# Access Compliance Report

## Public Rights-of-Way

Intersection ID: 18766	Main Street: CEDARBARK_DR	Cross Street: HUNTERS_RUN_LN	Location: SW
ADA ID: 8D93ADEBFA24	Ramp Type: PerpDiag	Initial Pass/Fail: Fail	Overall Compliance: No
		Severity Score: 37.5

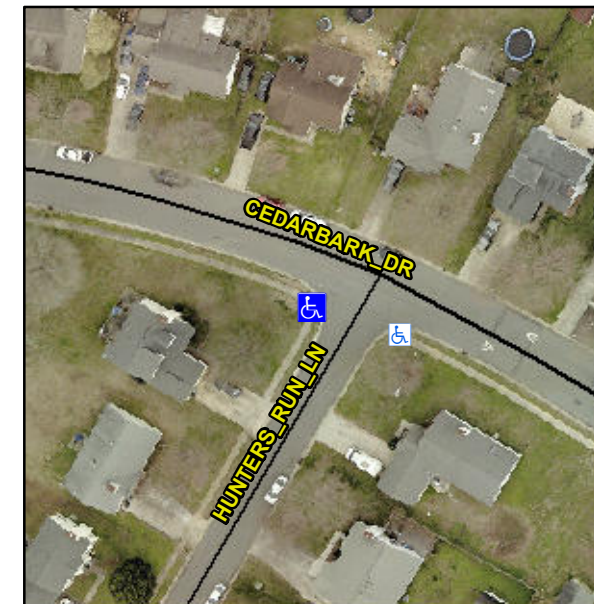
**Not Found, R304.2.2, R304.5.3**

Compliance	Description	Data	Compliance	Description	Data
N/A	Ramp Length (in)	47.0	No	Ramp Slope (%)	8.6
Yes	Ramp Width (in)	48.0	No	Ramp XSlope (%)	9.3
N/A	Flare Type LT	N/A	N/A	Flare Type RT	N/A
N/A	Flare Slope LT (%)	N/A	N/A	Flare Slope RT (%)	N/A
N/A	Flare Traversable LT?	N/A	N/A	Flare Traversable RT?	N/A
N/A	Landing Length (in)	N/A	N/A	DWS Provided?	N/A
N/A	Landing Width (in)	N/A	N/A	DWS Contrast?	N/A
N/A	Landing Slope (%)	N/A	N/A	DWS Length (in)	N/A
N/A	Landing X Slope (%)	N/A	N/A	DWS Full Width?	N/A
N/A	Landing Curb? (Y/N)	N/A	N/A	DWS Offset (in)	N/A
N/A	Shared Landing?	N/A			
N/A	Gutter Ponding?	N/A	N/A	Gutter Slope (%)	N/A
N/A	Gutter Lip Ht (in)	N/A	N/A	Gutter X Slope (%)	N/A
N/A	Painted X Walk1?	No	N/A	Painted X Walk2?	No
	X Walk 1 Direction	To SE		X Walk 2 Direction	To NE
N/A	X Walk 1 Width (in)	N/A	N/A	X Walk 2 Width (in)	N/A
	X Walk 1 Slope (%)	2.1		X Walk 2 Slope (%)	5.8
	X Walk 1 X Slope (%)	6.3		X Walk 2 X Slope (%)	1.5

**Remove & Replace Curb Ramp With Two New Directional Ramps or Equivalent.**
